A request by Bei Group Limited for a private plan change to the Auckland Unitary Plan (Operative in part) to rezone 13.7210 hectares at 473 Albany Highway, Albany from Residential – Mixed Housing Suburban to Residential – Terrace Housing and Apartment Buildings and to apply a new Albany 10 Precinct

**MEMORANDUM OF COUNSEL ON BEHALF OF BEI GROUP LIMITED
– RESPONSE TO HEARING PANEL DIRECTION #1**

Date: 28 June 2021

Figure I552.6.45.1 Building coverage and setback at upper levels

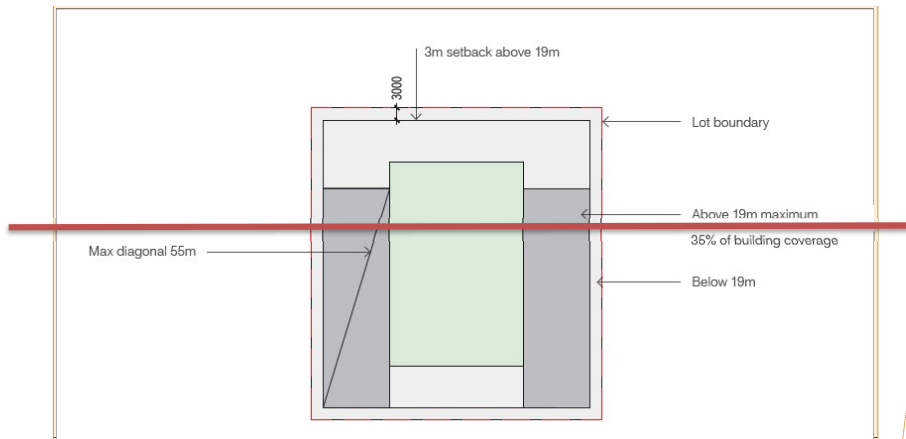
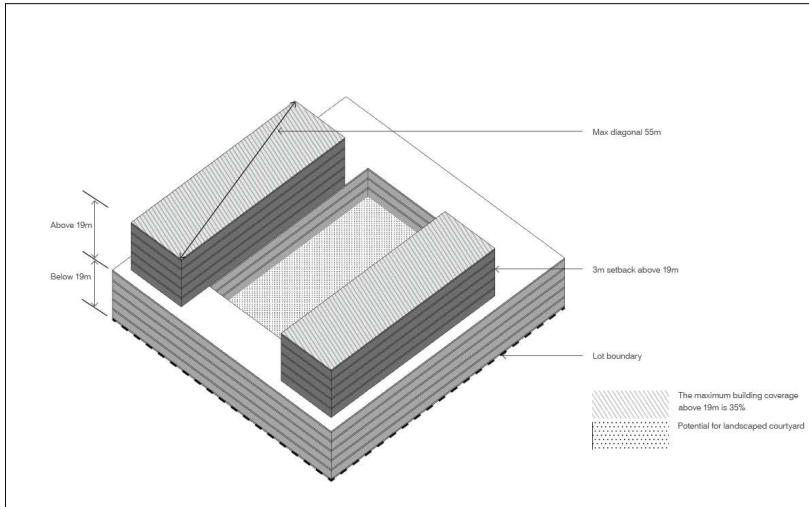
Commented [AC79]: 73.51 – Opposed in part to 6m upper-level setback.

Commented [AC80]: 73.51 – Figure deleted. Amended figure without colour and explanatory graphic in 3D included for interpretative ease.

Amended figure without colour and explanatory graphic in 3D included for interpretative ease.

Precinct Plan 2

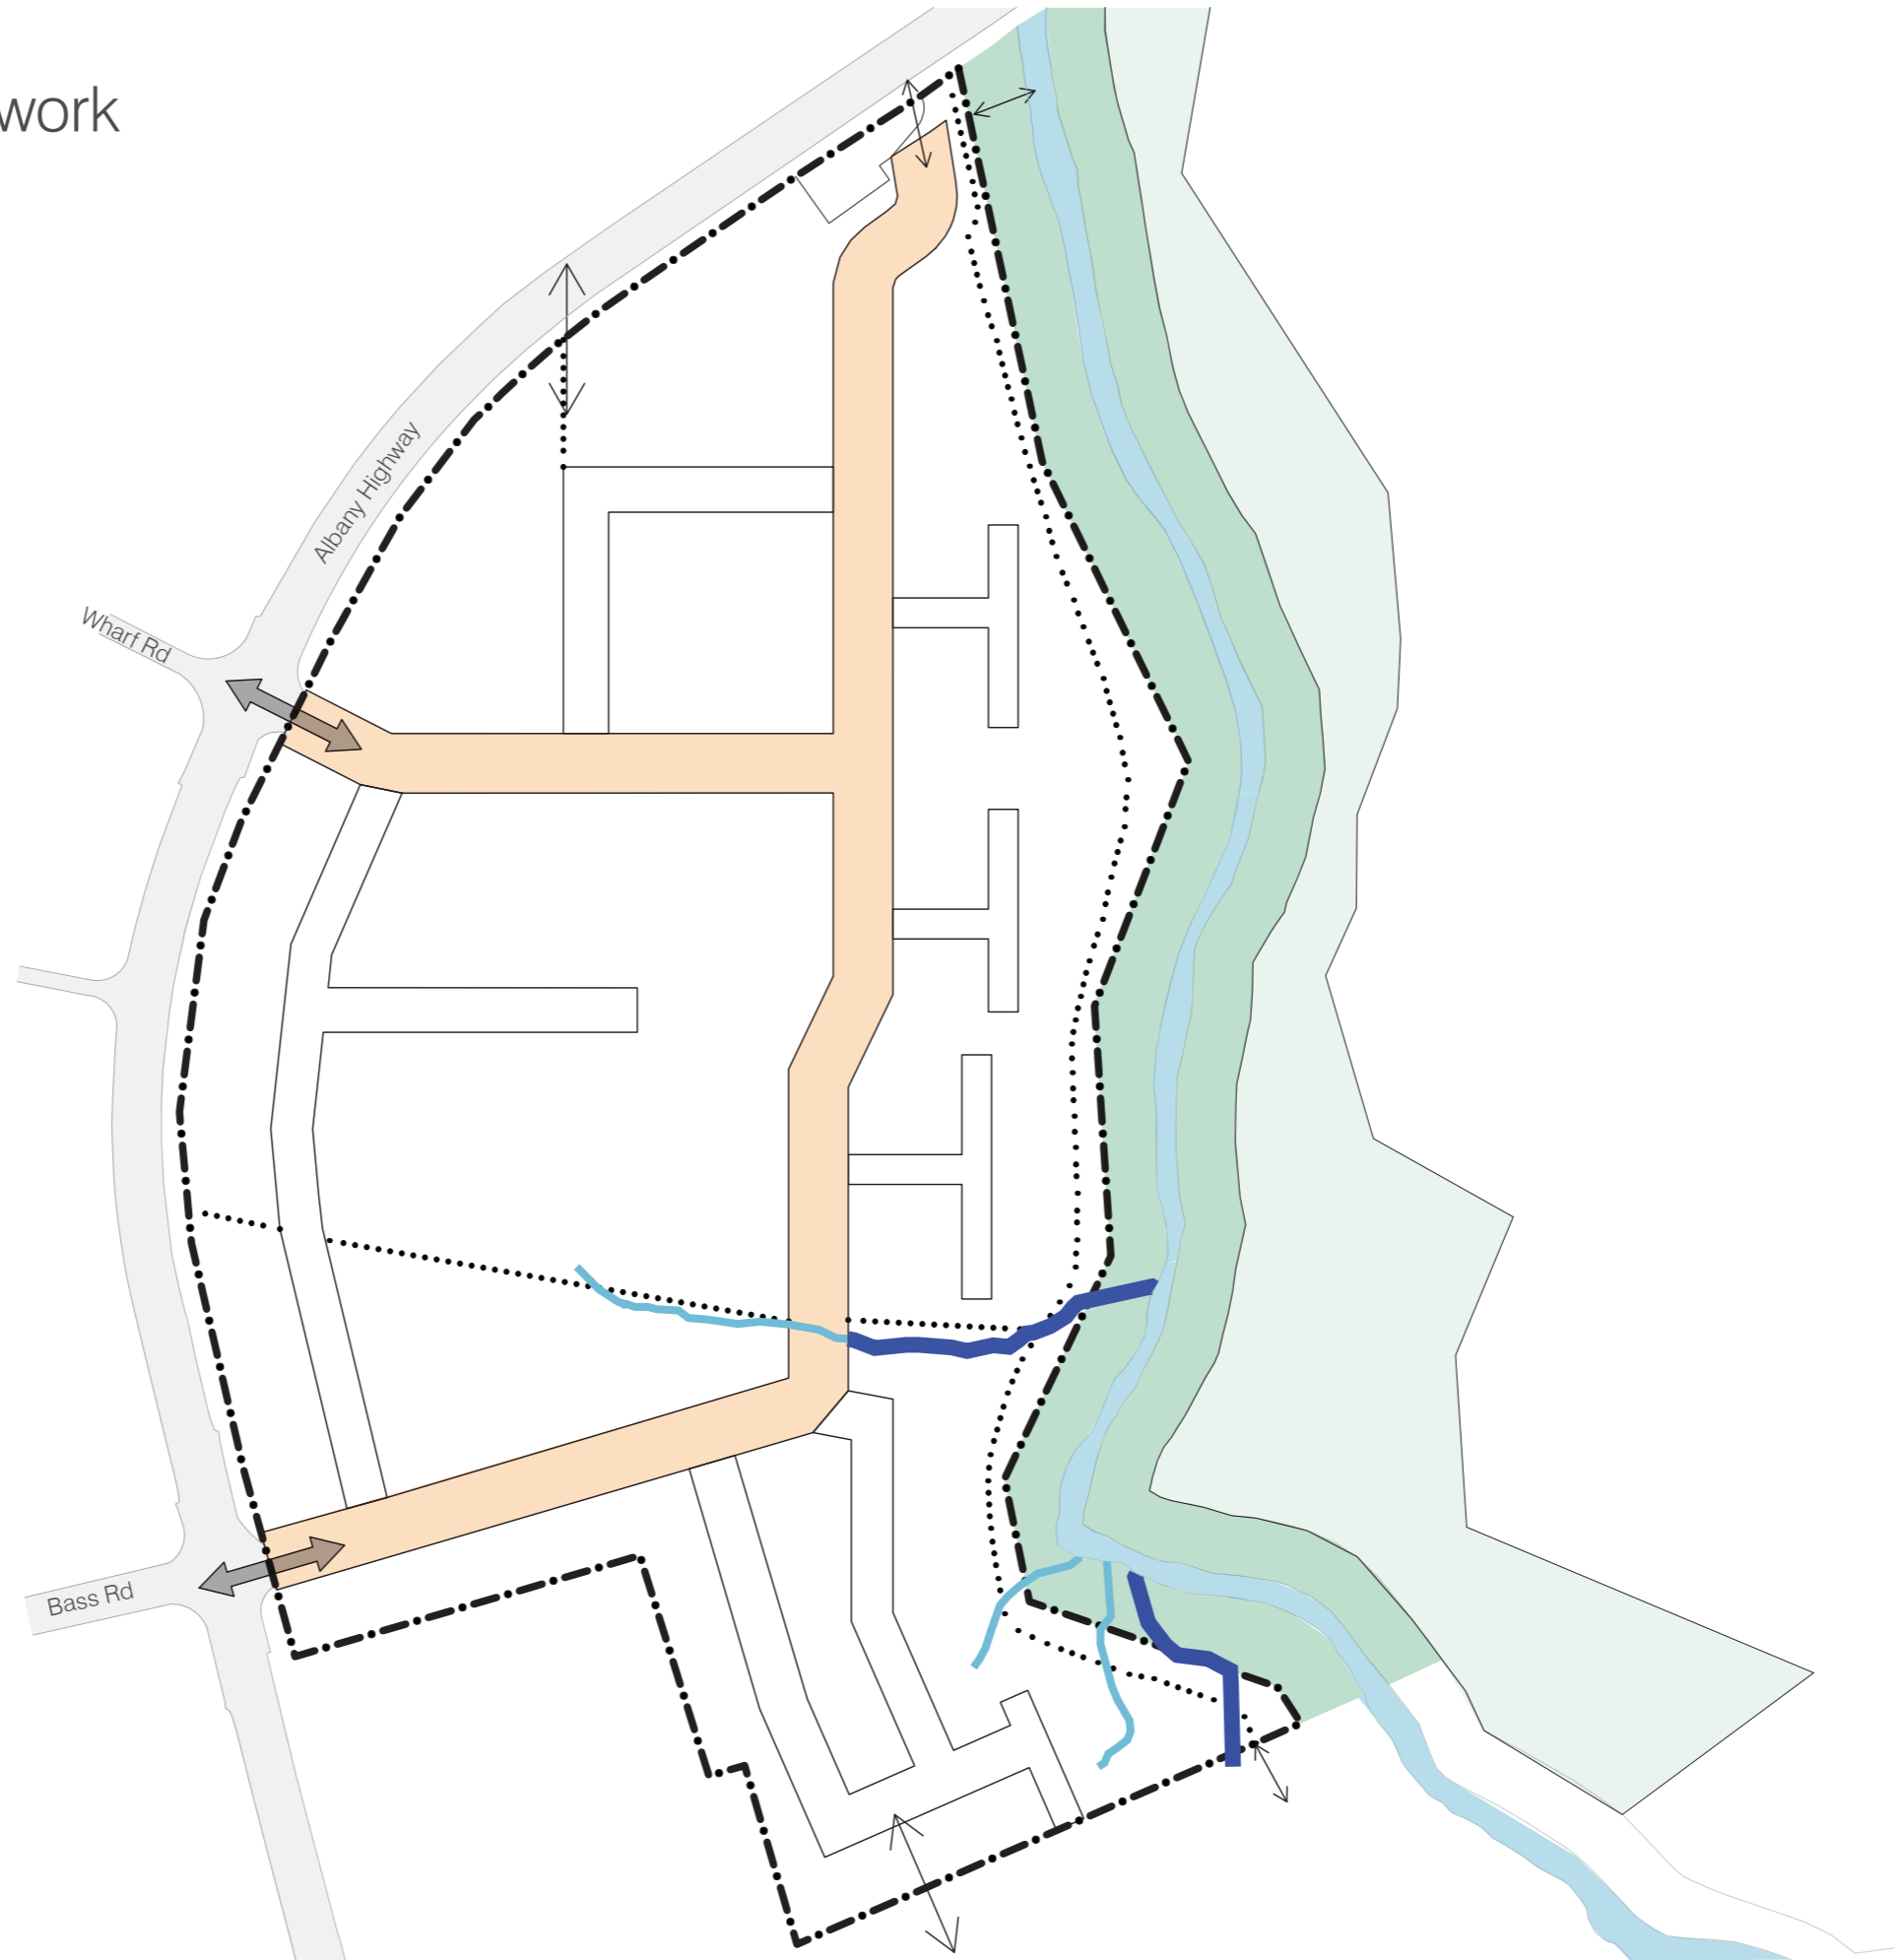
Commented [AT126]: 127.40 – Supported. Requested deletion of the northern vehicle access with amended precinct plans. Now provides for pedestrian/cycle connection only.
